TO: ALL PLANHOLDERS OF RECORD
RE: ITB 26T-DV-109 Kenaitze Pointe Mechanical Systems Upgrade
FROM: Rashaad Esters, Procurement Manager
PAGE(S): 5, including this cover sheet
DATE: May 4, 2026

ITB 26T-DV-109 Kenaitze Pointe Mechanical Systems Upgrade

Clarifications to be included in Addendum #2 for the Kenaitze Pointe – Mechanical Systems Upgrade Project

SHEET NO.
E3.3

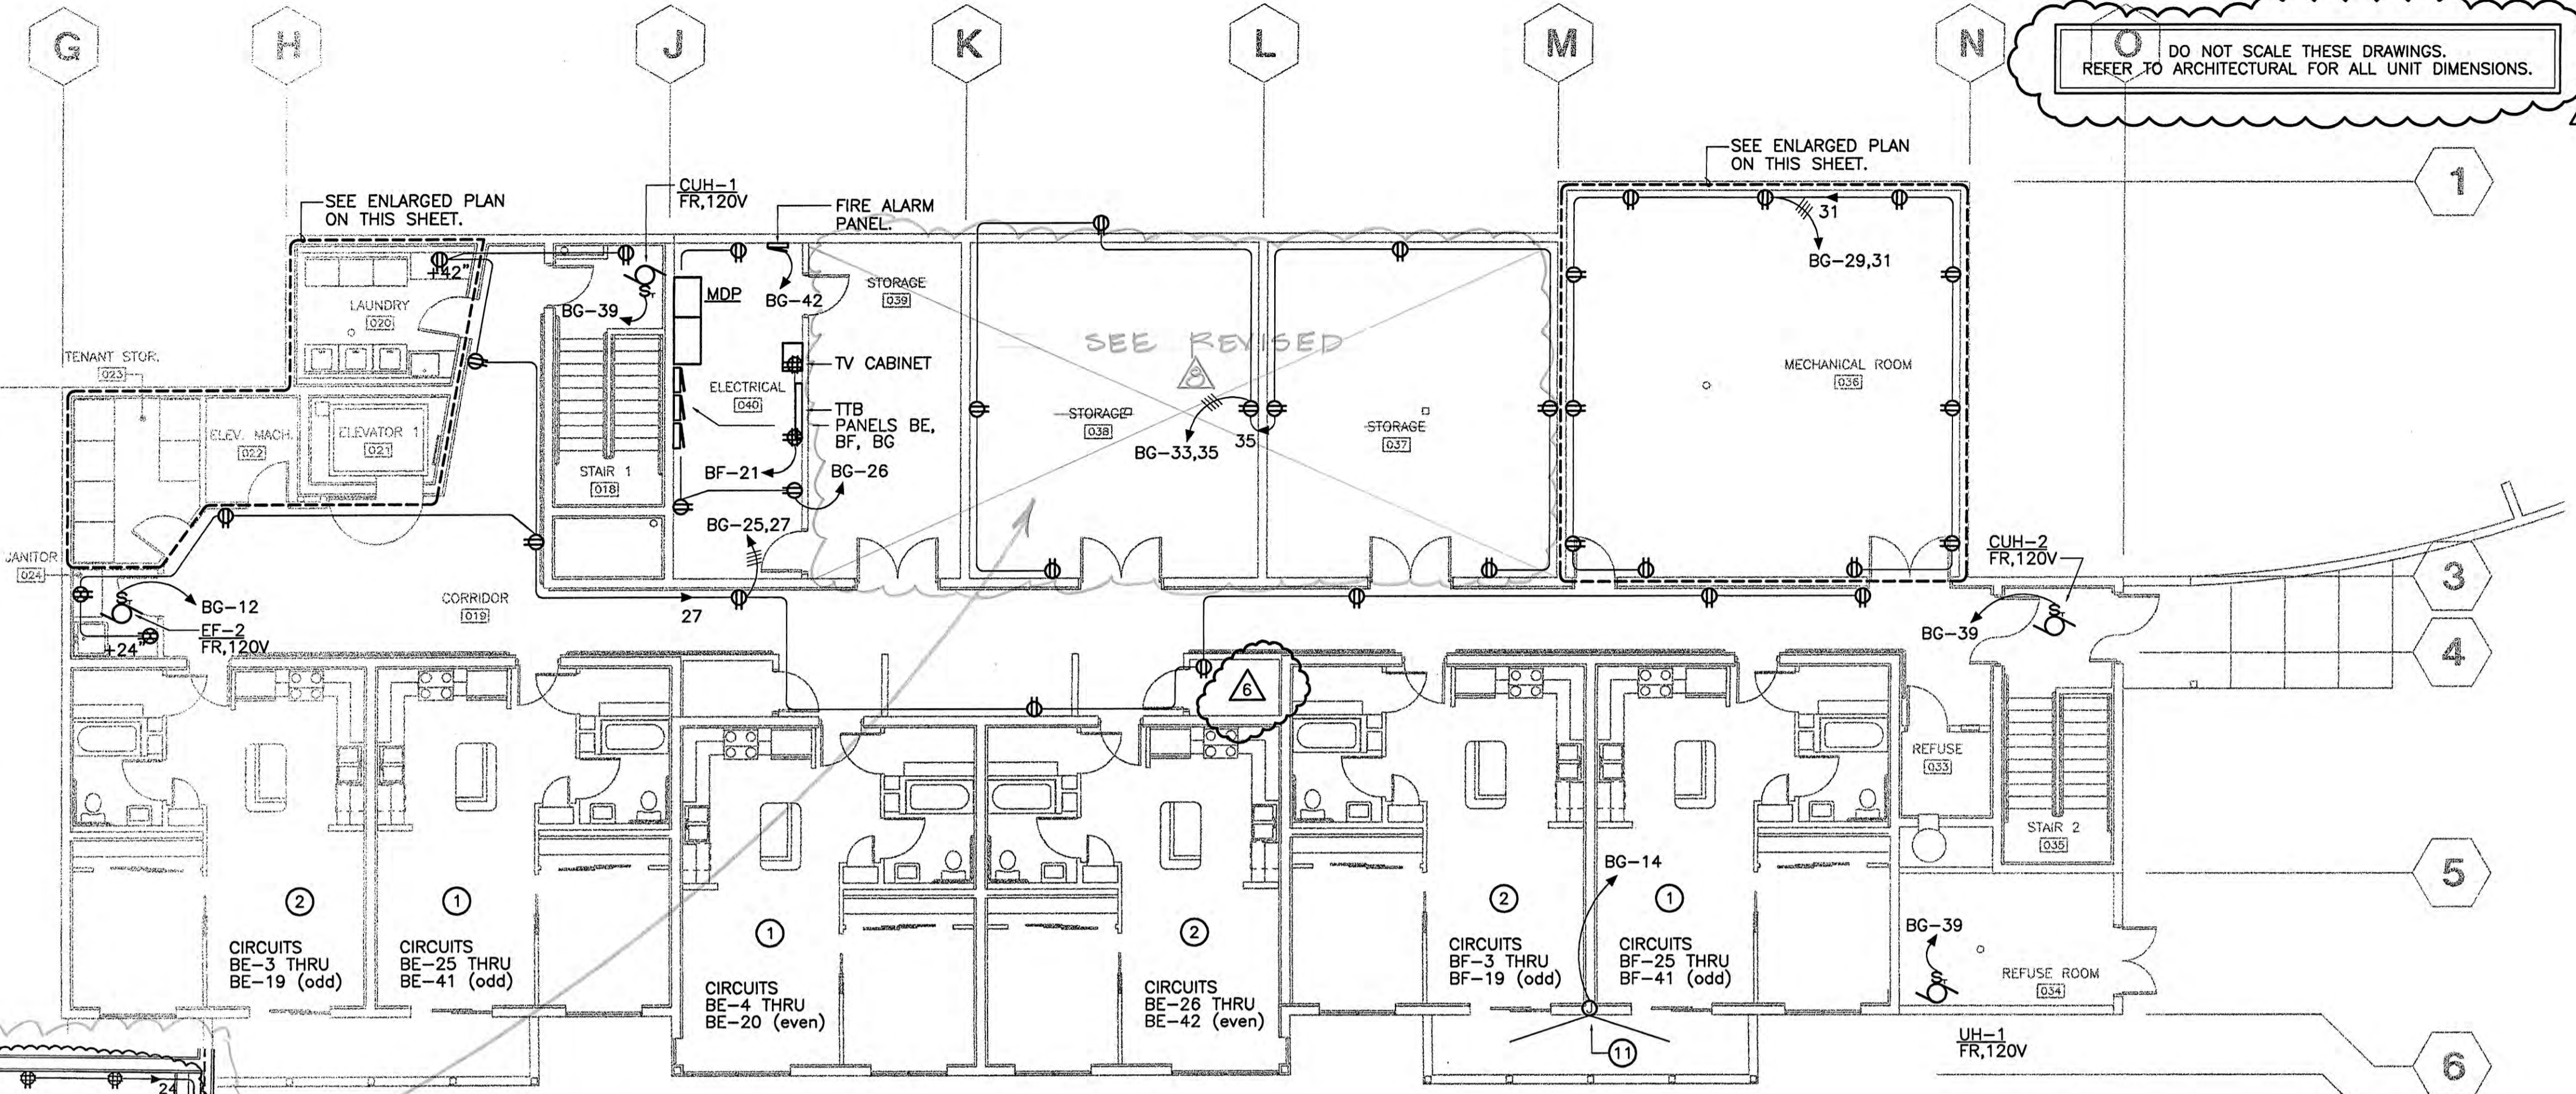
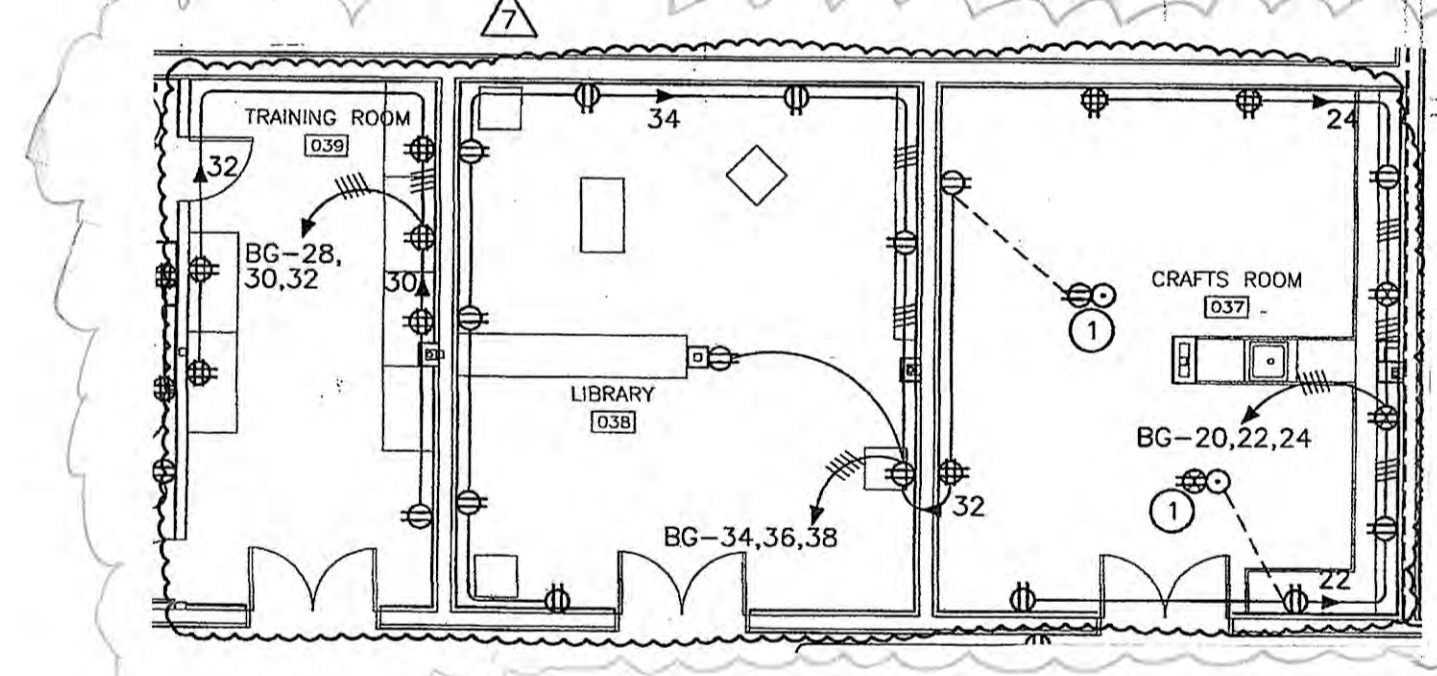
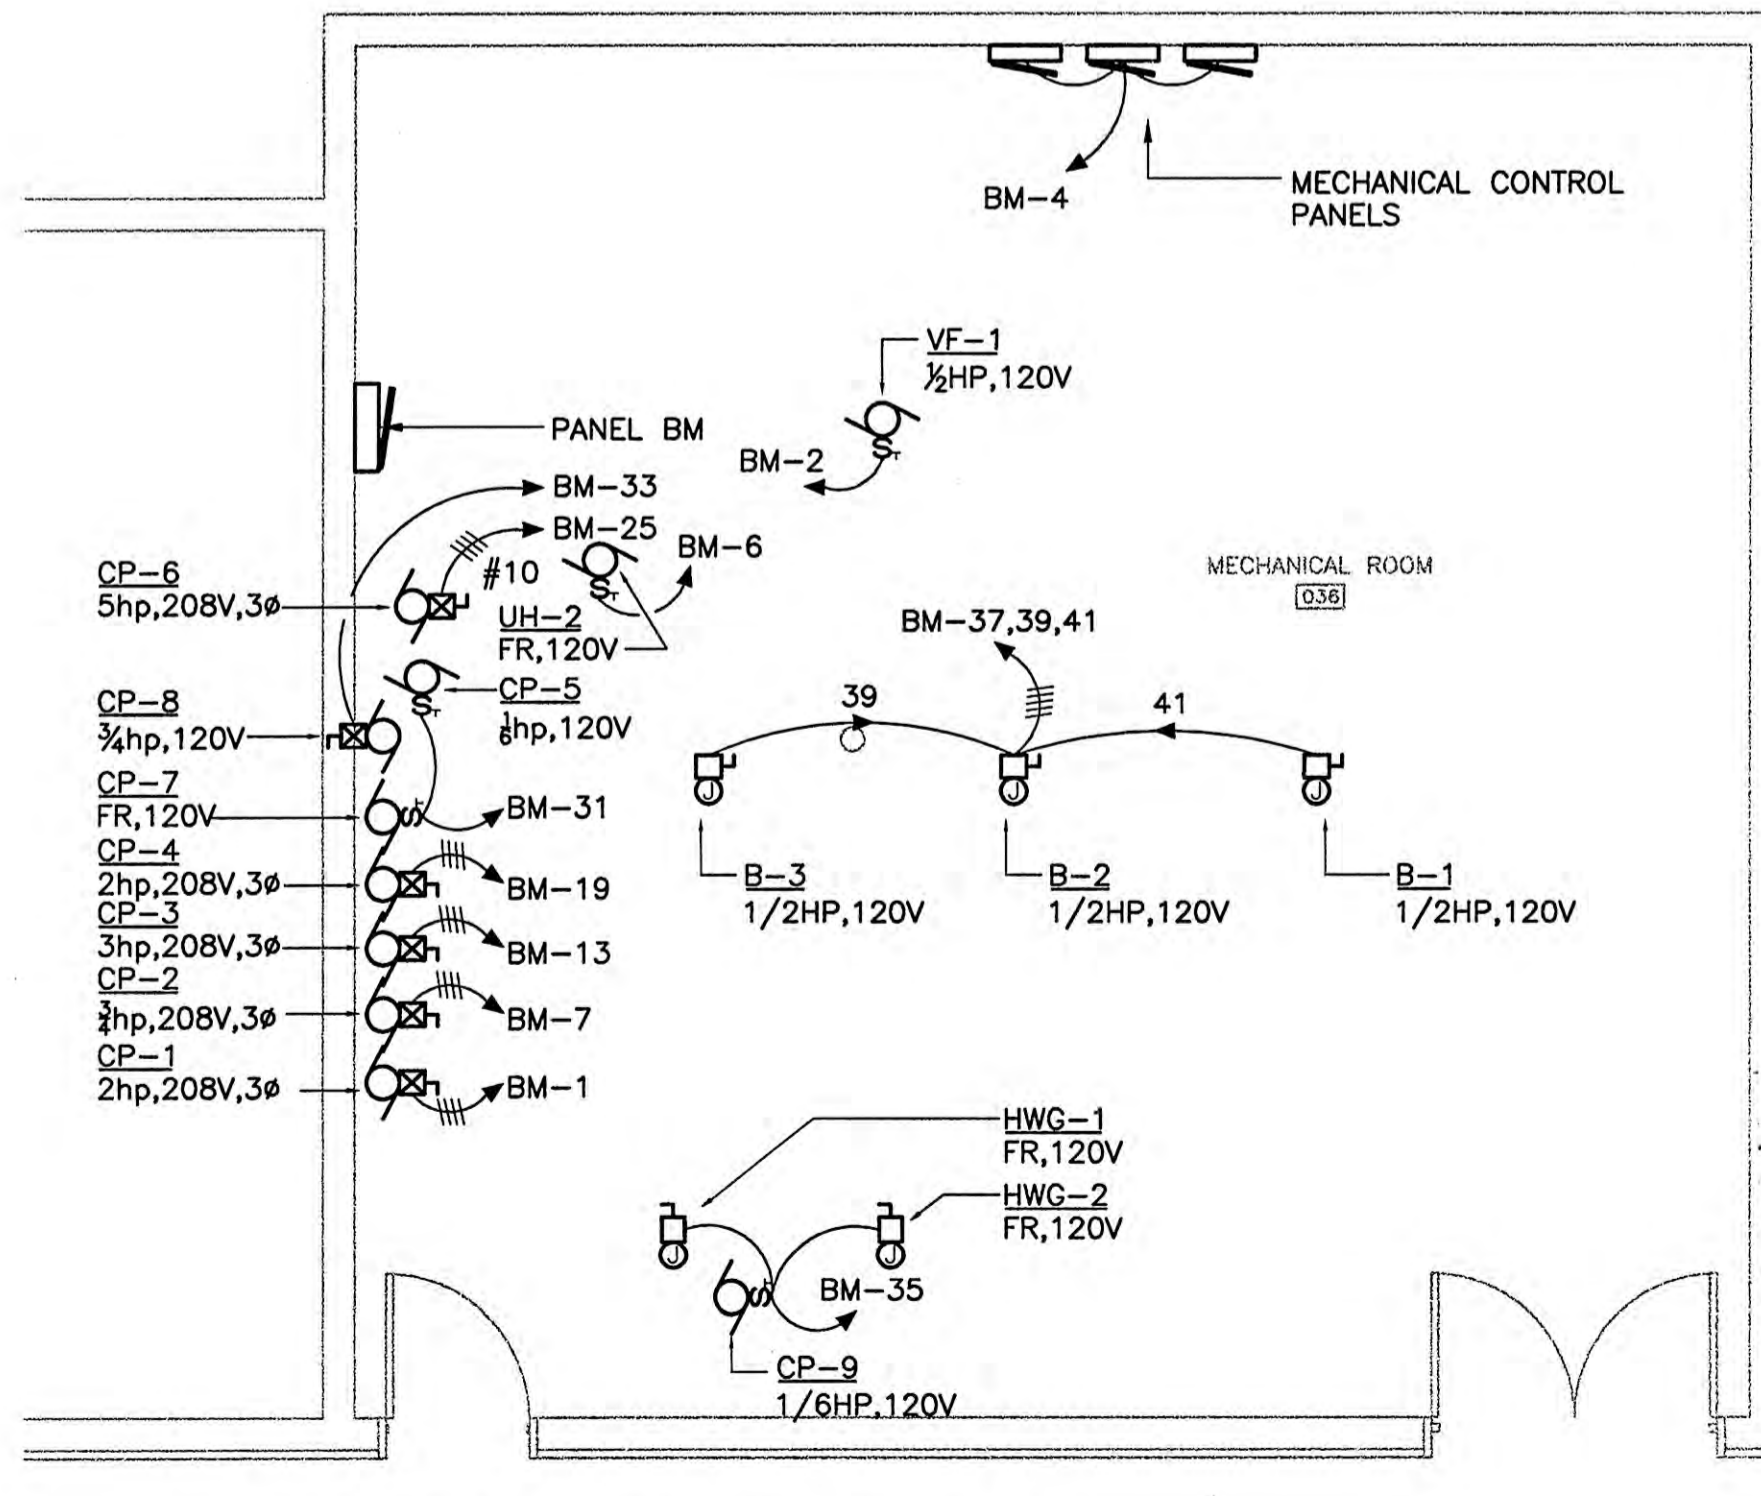
1. Alternate #3 shall include removal of both the existing in-use hot water generators and the abandoned hot water generators.
2. Sheet E3.3 from the 2002 Record Drawings is included to show existing circuitry in the mechanical room.
